Definitive Subdivision: Hiller & Timothy St. Subdivision DS 2019-01

- **Applicant:** Robert Roderiques;
- **Agents**: Schneider, Davignon, & Leone, Inc. (Engineers); John Mathieu (Attorney)
- **Owner(s):** Jimmy A. Papas and Nickolas L. Papas
- **Project Location:** Map 28C, Lots 71 and 71A. The proposal is to create frontage for the lots by creating new roads off of Hiller Avenue and Timothy Street. (15-acres total).
- **Proposal:** The proposal is to create sixteen (16) buildable lots with two drainage parcels on a 15-acre parcel of land through the definitive subdivision process. (**Based on Plans received May 28, 2019)**

Wetlands and 100’ Buffer on Site

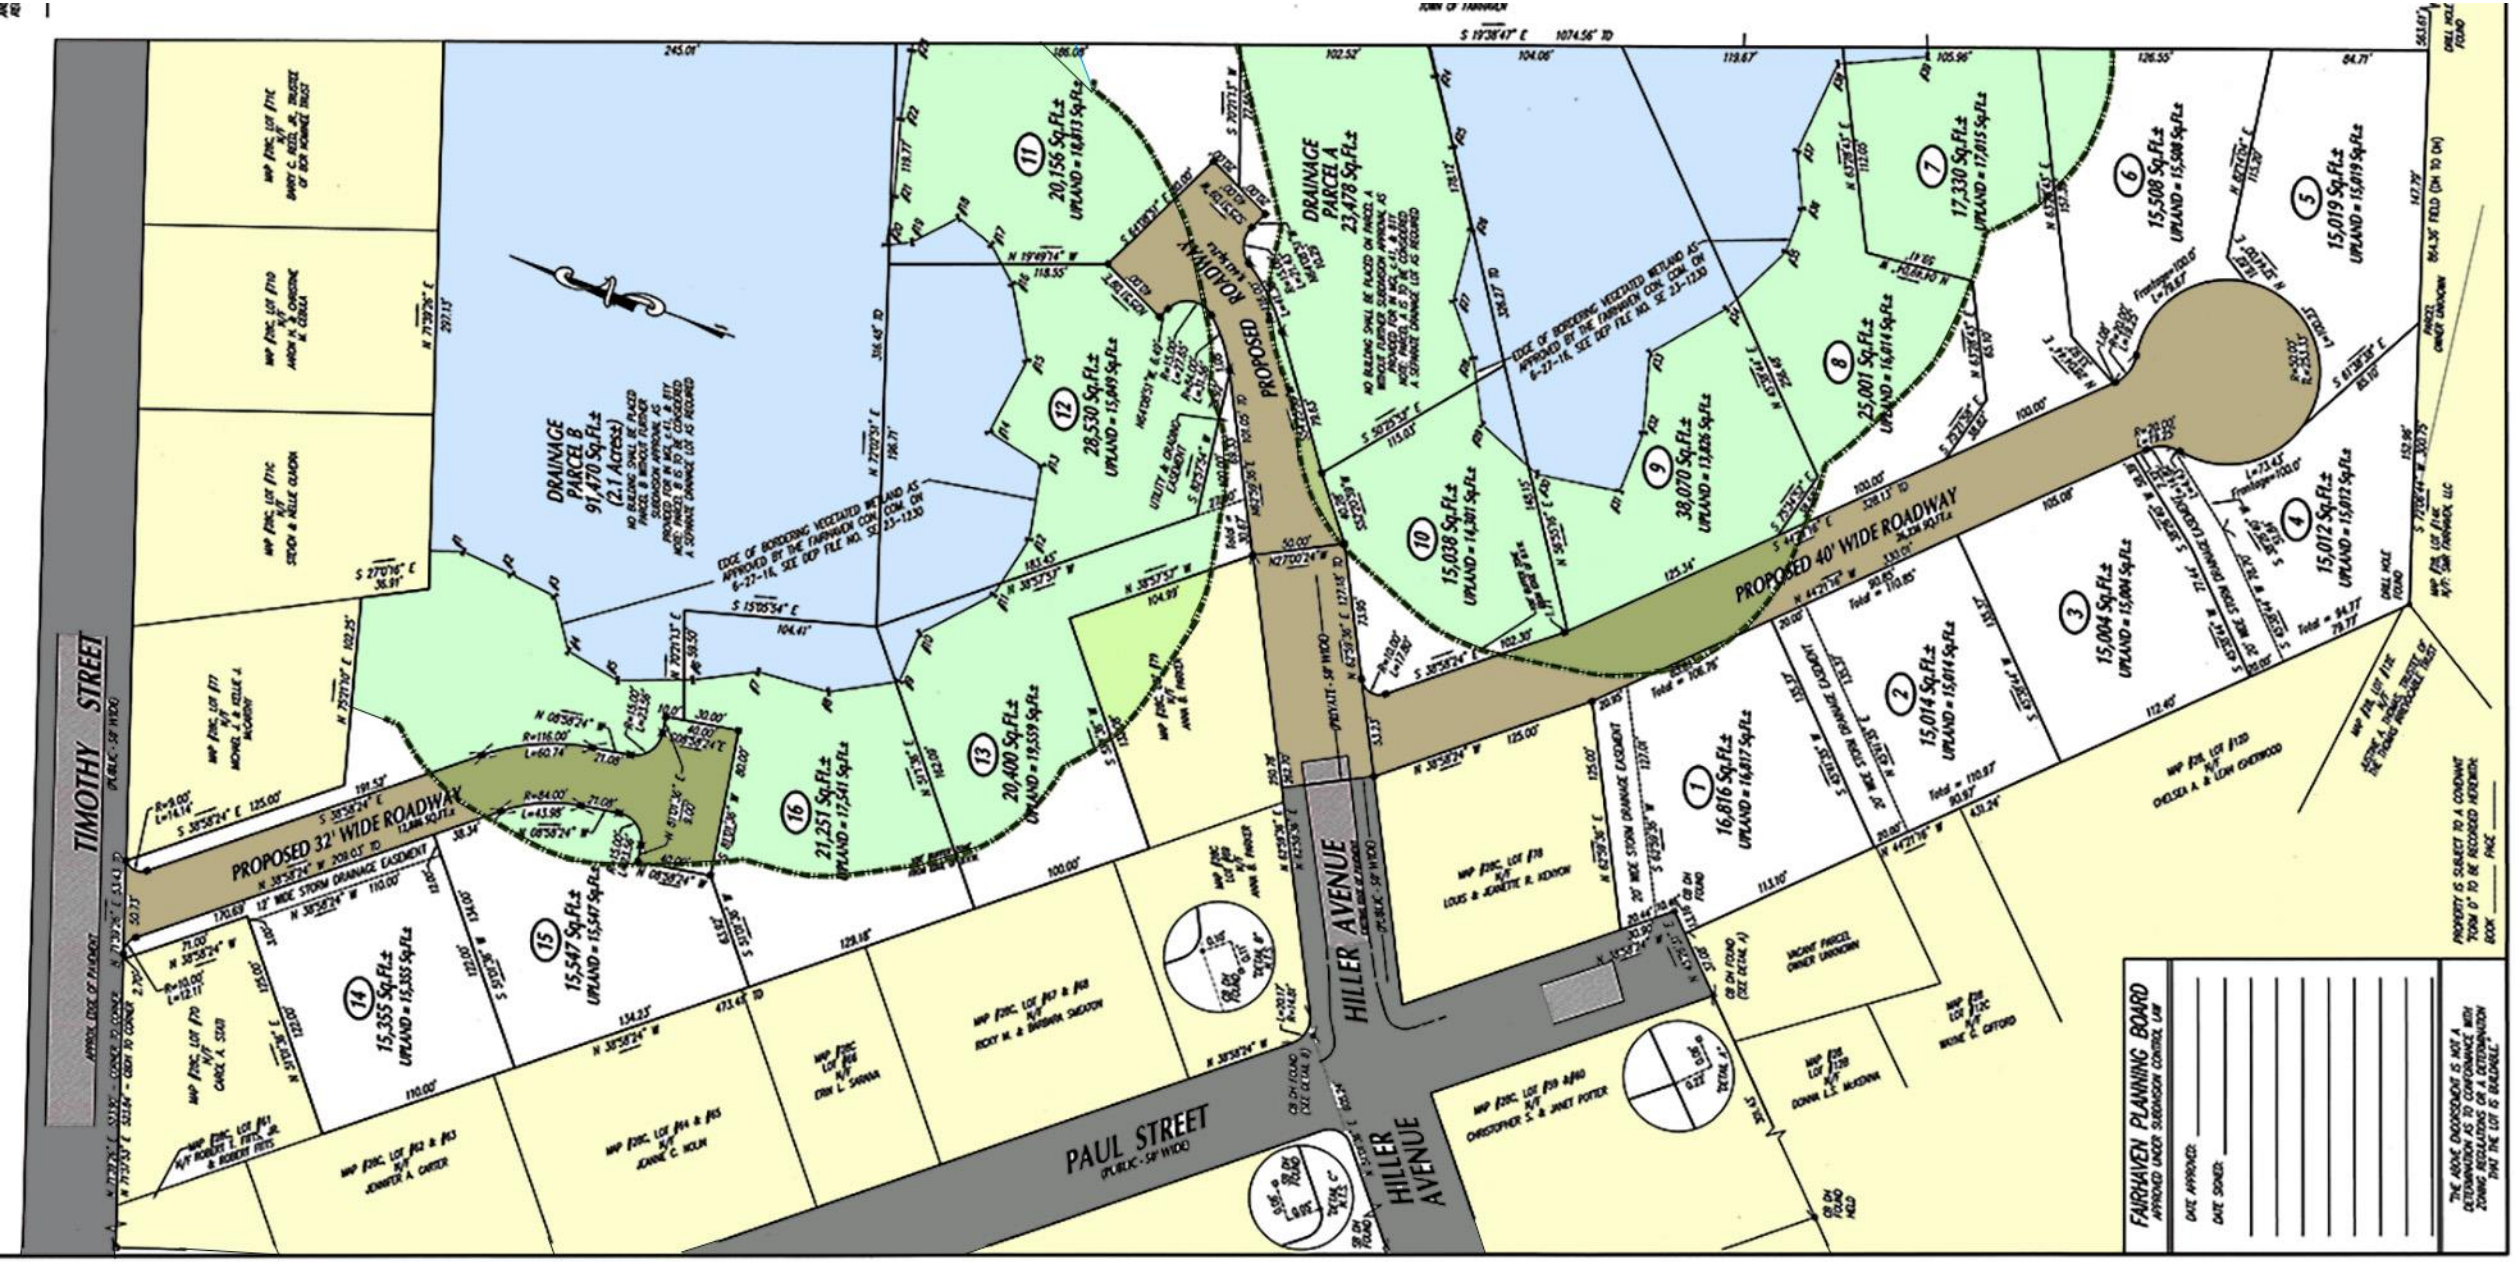
- Both proposed detention ponds are located directly next to the wetlands on the property and portions of all three proposed roadways fall within the 100-foot buffer zone to the wetland.

- Peer Review says no infiltration basins are allowed within 50’ of wetlands.
- Virtually any activity on 11 of the 16 proposed lots would require filing a Notice of Intent (NOI).

NEIGHBORHOOD AERIAL EXHIBIT PLAN

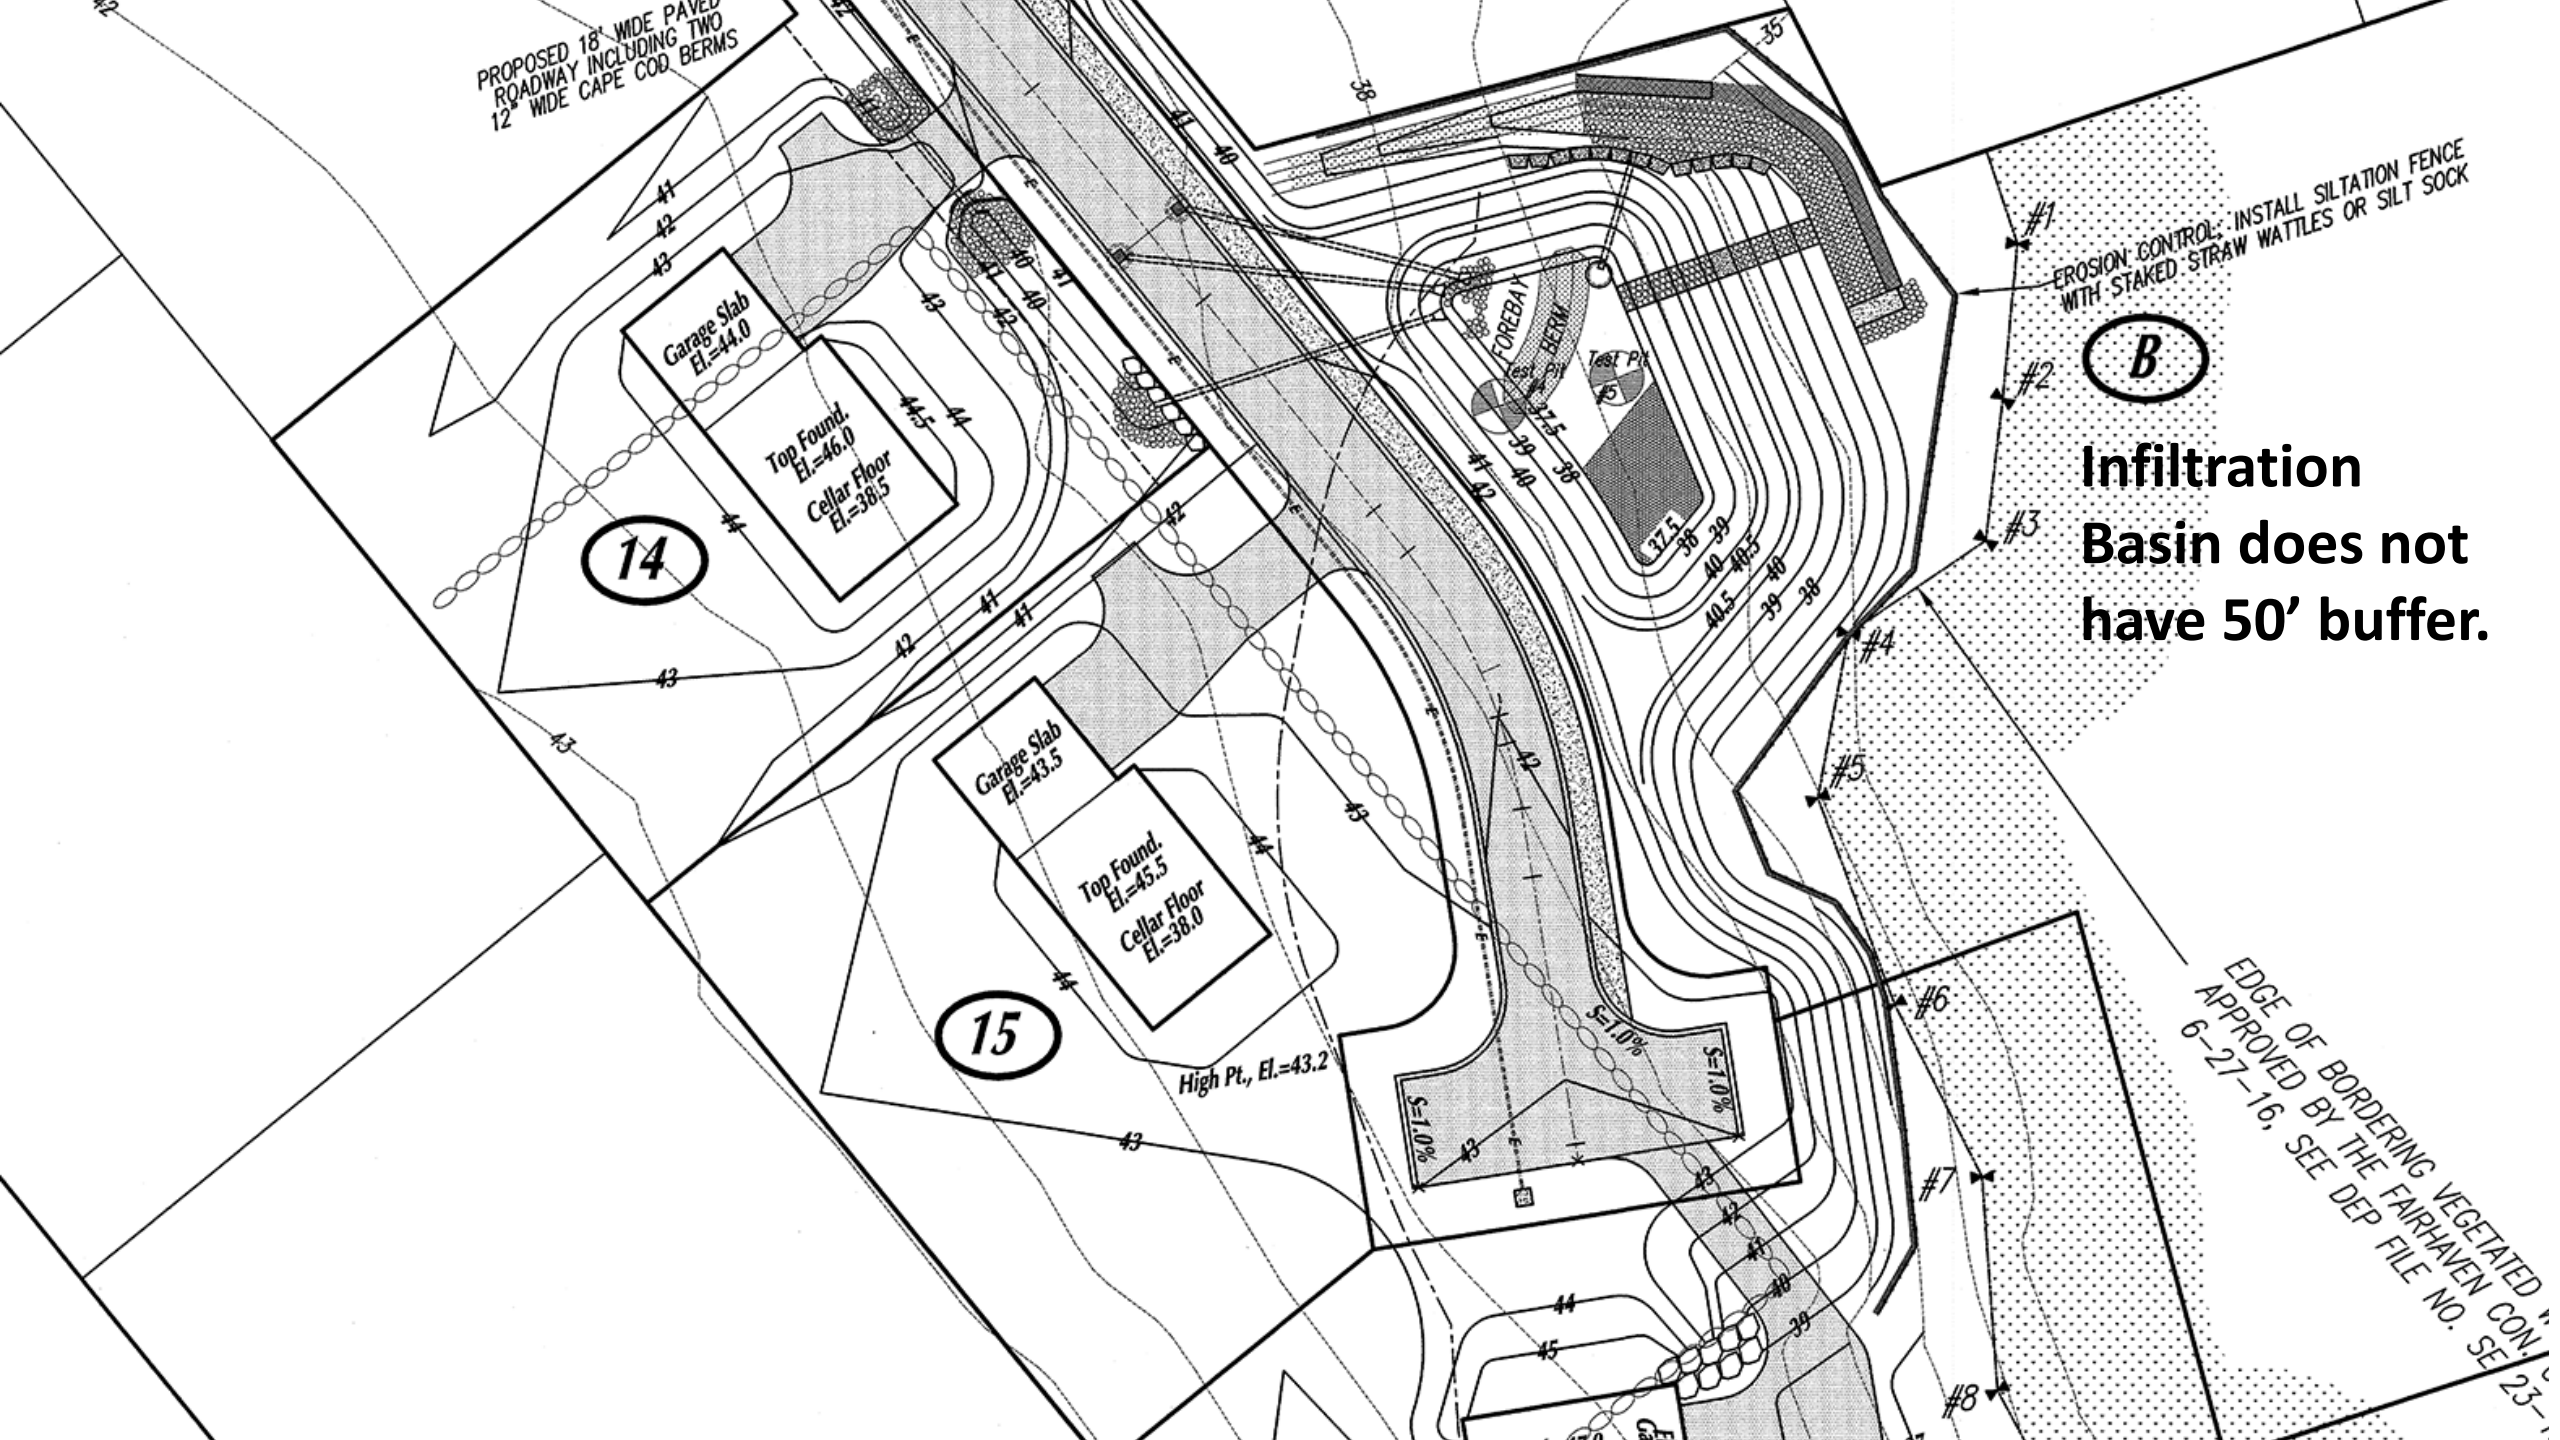
Infiltration Basin does not have 50' buffer.

- Infiltration Basin does not have 50’ buffer.
- Lot 79 hemmed in.
- Lot 78 hemmed in.
